Project	IEEE 802.16 Broadband Wireless Access Working Group http://ieee802.org/16 >		
Title	Correction for UL-MAP processing time mismatch		
Date Submitted	2004-11-01		
Source(s)	Intel.		
	Yuval Lomnitz	Yuval.Lomnitz@intel.com	
	Yigal Eliaspur	Yigal.Eliaspur@intel.com	
	Noam Kogan		
	Dov Andelman		
Re:	IEEE P802.16REVd/D5-2004		
Abstract	Correct UL MAP processing time definition		
Purpose	Adopt changes to definition of UL-MAP processing time (Tproc) in OFDMA		
Notice	This document has been prepared to assist IEEE 802.16. It is offered as a basis for discussion and is not binding on the contributing individual(s) or organization(s). The material in this document is subject to change in form and content after further study. The contributor(s) reserve(s) the right to add, amend or withdraw material contained herein.		
Release	The contributor grants a free, irrevocable license to the IEEE to incorporate material contained in this contribution, and any modifications thereof, in the creation of an IEEE Standards publication; to copyright in the IEEE's name any IEEE Standards publication even though it may include portions of this contribution; and at the IEEE's sole discretion to permit

Figure 1 – UL-MAP processing example: TDD

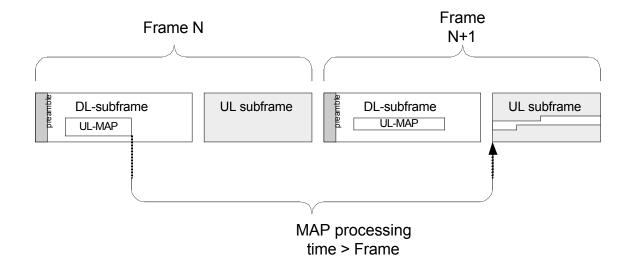
In order to prevent contradictions we suggest to define UL-MAP processing time as proportion of frame duration. The logic behind this definition is that most of the work on UL-MAP is proportional to the potential amount of data to transmit, which is proportional to frame duration. This emposes the minimum restriction on the SS required for system operation.

The proposed definition is:

T proc = frame duration
